Customer Notification

V850E/PH03

Operating Precautions

No. 14 ADC: When reading the ADCRnm registers asynchronously the conversion result from previous channel might be provided. (Specification change notice)

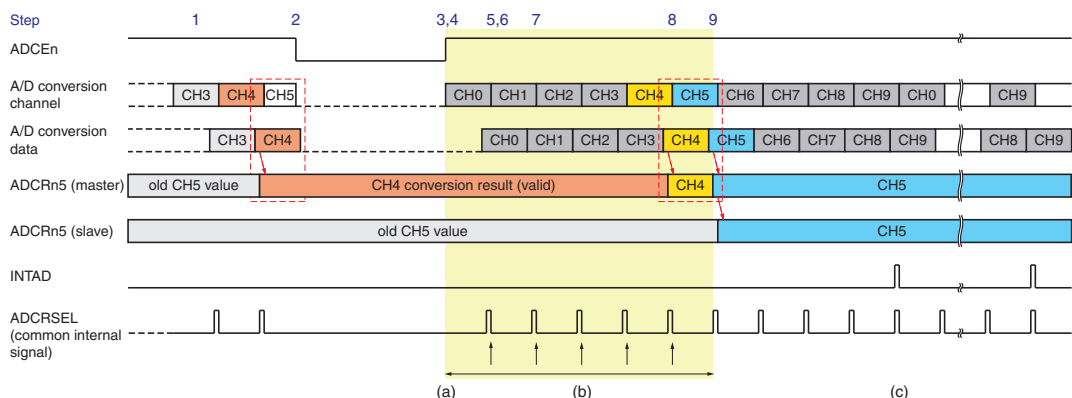
When the A/D converter (ADC) is operating in scan mode and is stopped asynchronously (by clearing the ADCEn bit, rewriting of ADMn0/ADMn1/ADMn2 registers, or an enabled external or timer trigger event) the internal current ADCRnm master register might be loaded with the conversion result of the previous converted channel.

After AD conversion restart (by setting the ADCEn bit, or automatically after rewriting of ADMn0/ADMn1/ADMn2 registers, or by the enabled external or timer trigger event) the ADCRnm master register still holds the conversion result of the previous converted channel.

When the concerned conversion result register (ADCRnm) is read during the conversion time, the conversion result of the previous channel may be read, if at that time the internal ADCRSEL signal is active (for an ADC clock period of 62.5 ns).

Because of the small timing window (62.5 ns), a consecutive read of same ADCRnm register will never result in two invalid values.

- (a) Restart of A/D converter.
- (b) For instance when ADCRn₅ register is read after restart of the A/D converter during period (b) at the timing of an active ADCRSEL signal (1 x ADCLK = 62.5 ns), the conversion result may be read from ADCRn₅ master register, which holds the result of the previous channel 4 at that time, rather than from the ADCRn₅ slave register.
- (c) After first INTADn occurrence, proper read of all ADCRn_m registers is ensured.

When the ADC is stopped asynchronously during scan mode operation apply one of the following three procedures when reading the conversion results after reconfiguration and restart of the ADC.

- Use DMA transfer to obtain AD conversion results (ADDMA_n register).
- Read ADCRn_m registers in a corresponding INTADn service routine.
- Synchronize the first read of ADCRn_m registers with the first occurrence of the INTADn interrupt after restart of the ADC (without applying an interrupt service routine)
 - Clear ADICn.IF flag during reconfiguration and check ADICn.IF flag before reading the ADCRn_m registers.
 - In case of external or timer trigger ensure that the period b/w two consecutive trigger events is greater than the scan period of all selected channels. (refer to precaution 15.8 (2) in UM)
